# ICHD–ENVIRONMENTAL HEALTH DIVISION

Statesville Office (704) 878-5305 Mooresville Office (704) 660-3625 PERMIT # 328063

## SEPTIC IMPROVEMENT PERMIT / AUTHORIZATION TO CONSTRUCT / OPERATION PERMIT / EXISTING SYSTEM

SITE ADDRESS: 219 Freshwater Lane Mooresville NC 28117. PHONE: 704-360-0376 ALT. PHONE –

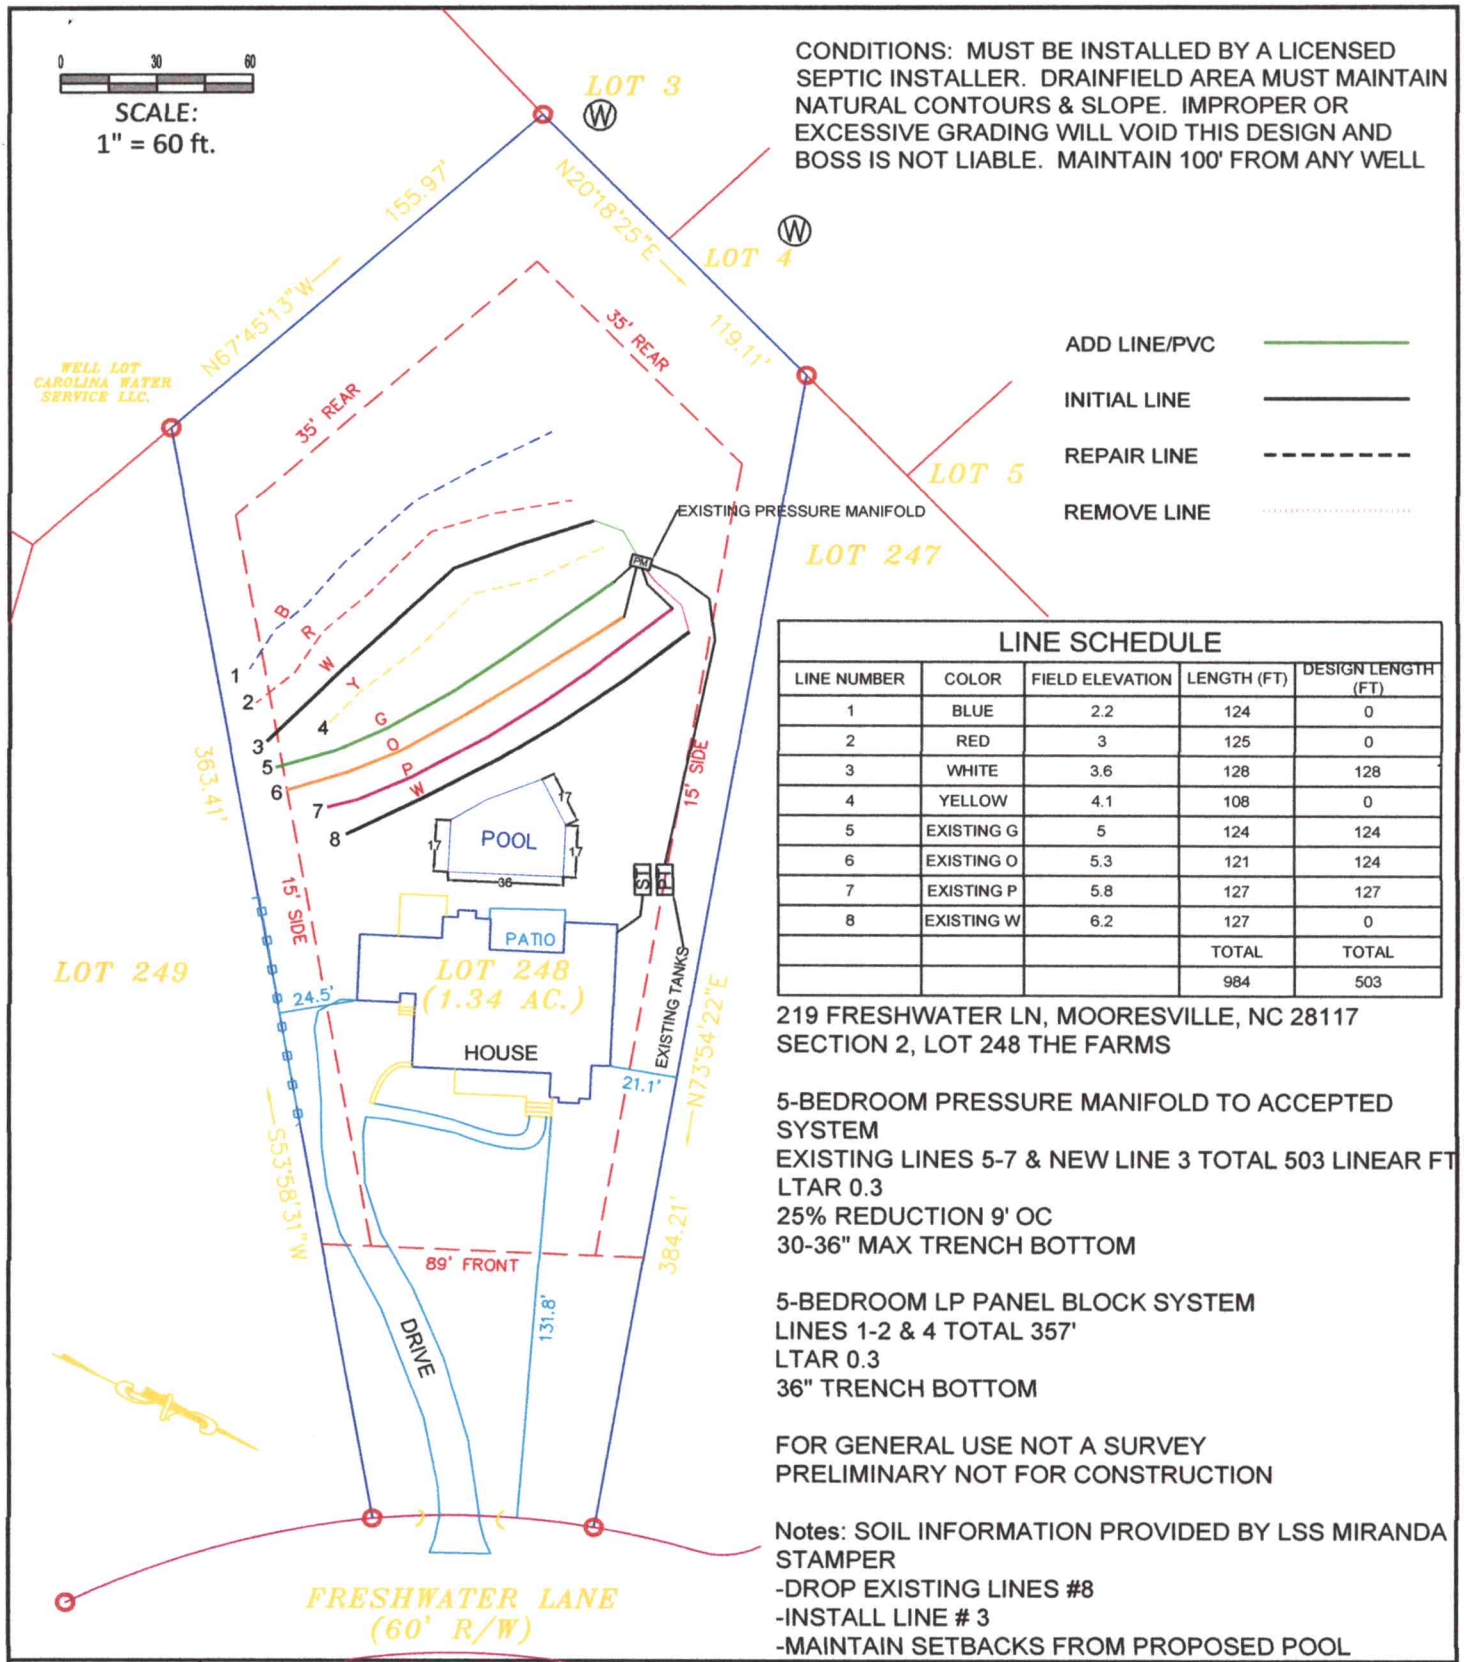
Comments / Conditions: Remove existing line to close to pool - Replace with new line as shown. Keep 5ft from Pool.

Comments / Conditions: Remove existing line to close to pool - Replace with new line as shown. Keep system 15ft from Pool.

New line checked - not plumbed 9/1/22 DW
